Groundwater Transfer Review Summary Form

Transfer/PA # T- 14781

Application: T-14781

Applicant Name: Kittredge Properties LLC

T-14781 Application Map

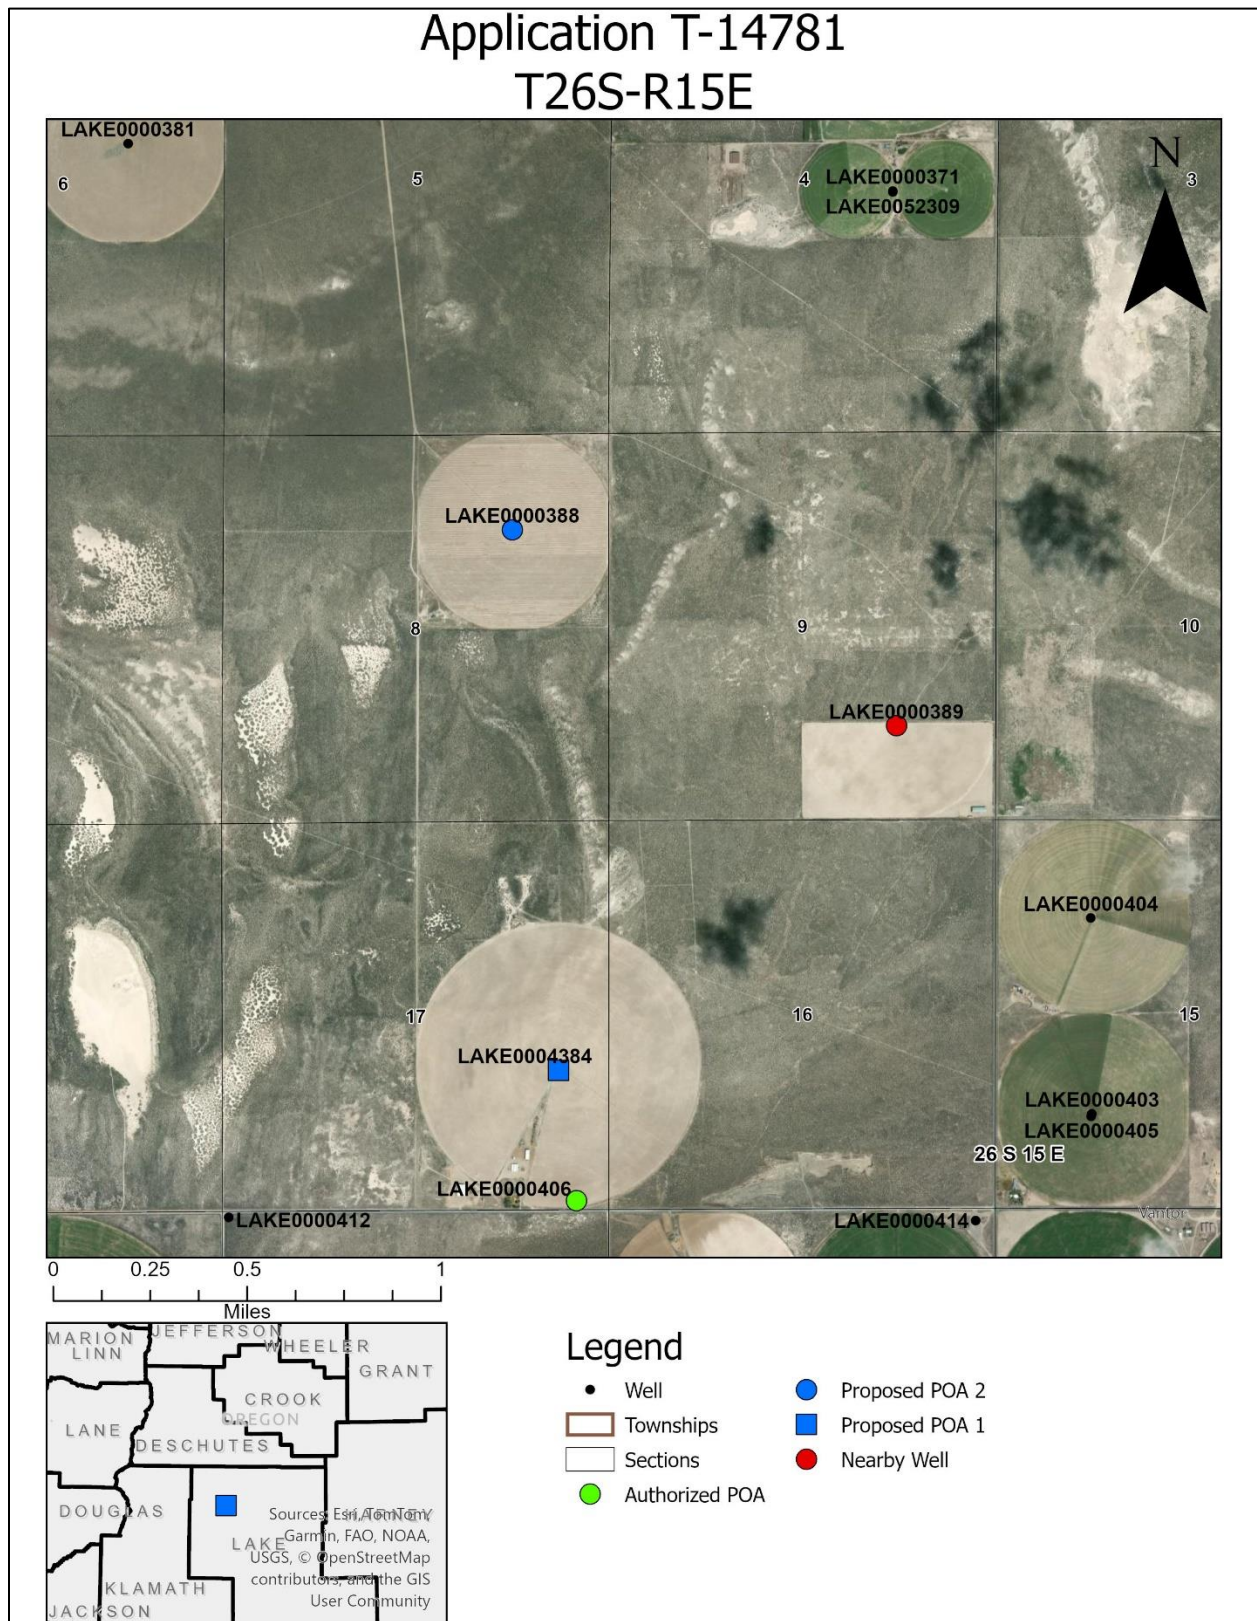
Additionally, applicant is requesting to transfer places of use from the SW pivot corner totaling 35.42 acres (map and screenshots below) to within the pivot that seemingly haven't had water applied since 1985 according to satellite imagery from Google Earth. Transferring this POU to the new pivot may result in enlargement and should be reviewed by the watermaster. Imagery from 1985, 1994, 2000, 2003, 2005, 2006, 2011, 2012, 2014, 2020 and 2023 shows possible nonuse for that portion of GR-1500.

Drawdown from Proposed POA 1**Theis Time-Drawdown Worksheet v.5.00**

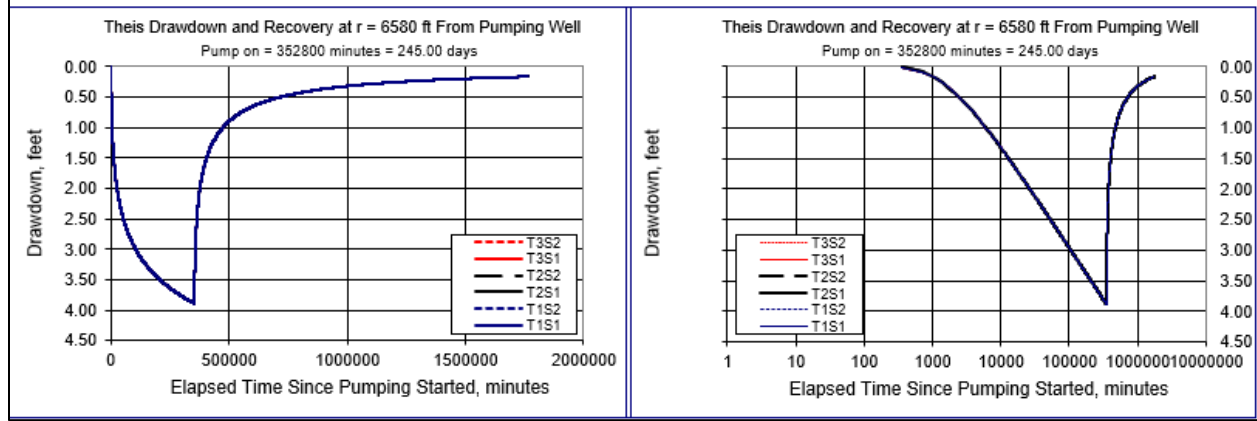
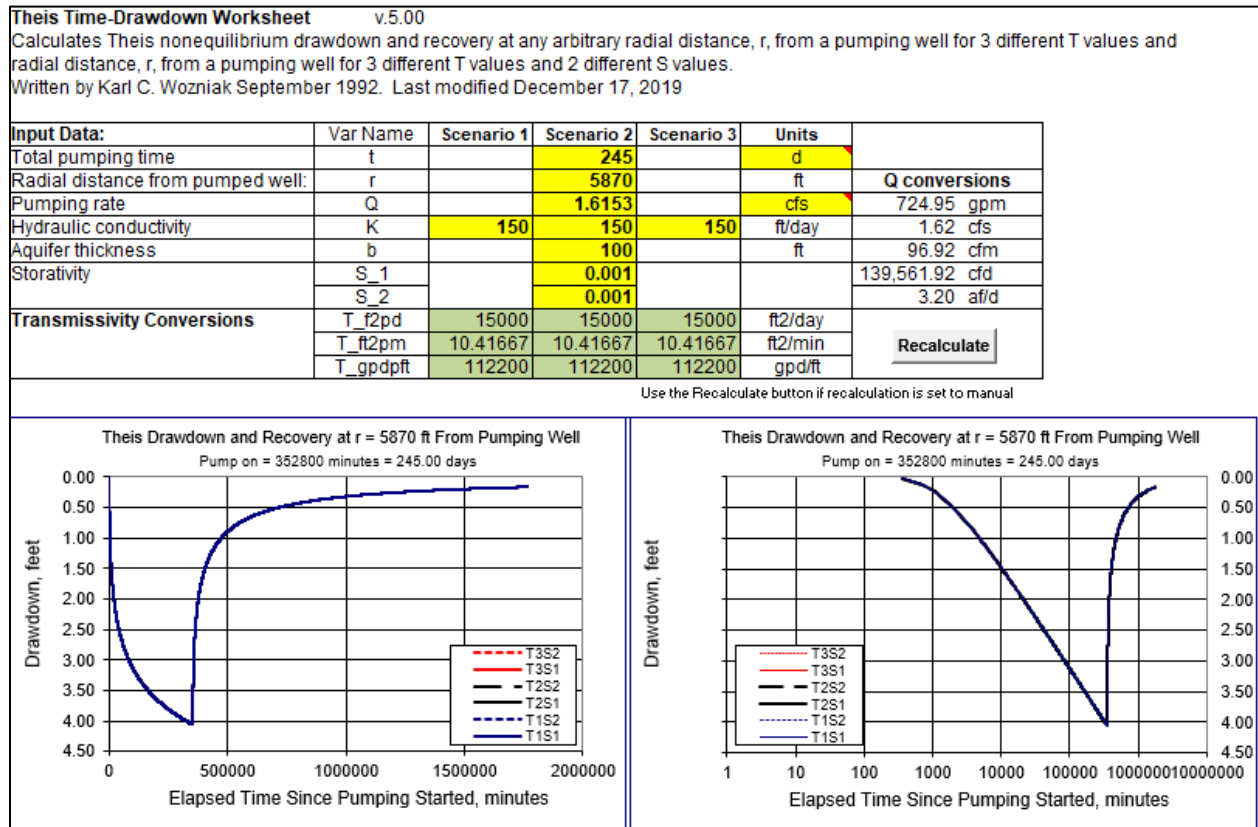
- b) If yes, would this proposed change, at its maximum allowed rate of use, likely result in another groundwater right not receiving the water to which it is legally entitled?
☐ Yes ☒ No If yes, explain: LAKE 4384 is 6580 ft away from LAKE 389 and LAKE 388 is 5870 ft from LAKE 389. Estimated drawdown from the requested changes was calculated using the Theis equation (attached below) for the projected pumping from the authorized POA, proposed APOA and the affected well using an intermediate storage coefficient of 0.001 and transmissivity of 15,000 ft²/day (McFarland and Ryals, 1991), and assuming constant use at max rate. Using these conservative parameters, maximum drawdown is estimated to be 3.89 ft from LAKE 4384, 4.06 ft from LAKE 388, and 8.69 ft from the affected well which would total of 16.64 ft of drawdown in the affected well, which would not meet the standard of "substantial or undue interference".
